Letter: **ST-006-2020**

Subject: **Variable Speed Air Handler Wire Harness**

Product: **Residential Air Handlers models: AVC, AVV and MVC**

Summary: **This letter is to advise of a possible harness mis-wire found on the variable speed residential air handler wire harness that controls the ECM motor, Electric Heat, and Transformer.**

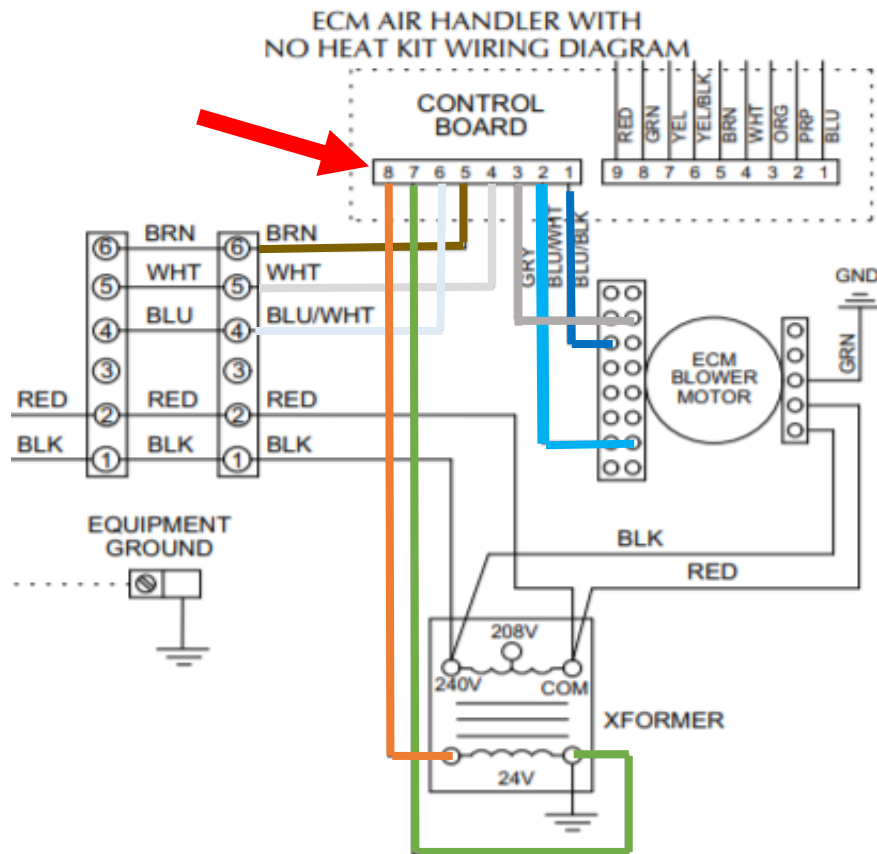
Through our investigations, we have discovered that the **Wire Harness** that provides PWM signal and VAC out of the control board to be mis-wired. We have found the mis-wire at the control board connection, mis-wired at the 16 pin male Molex plug connection going into the variable speed motor and the electric heat kit. The mis-wire harness is shown below.

The correct colored wiring of the harness is shown below.

If you encounter one of the subject air handlers with this issue, please replace the **Wire Harness** with part number **S1-02546389000**. This part can be obtained under the standard warranty process with 2 hours of labor claim.
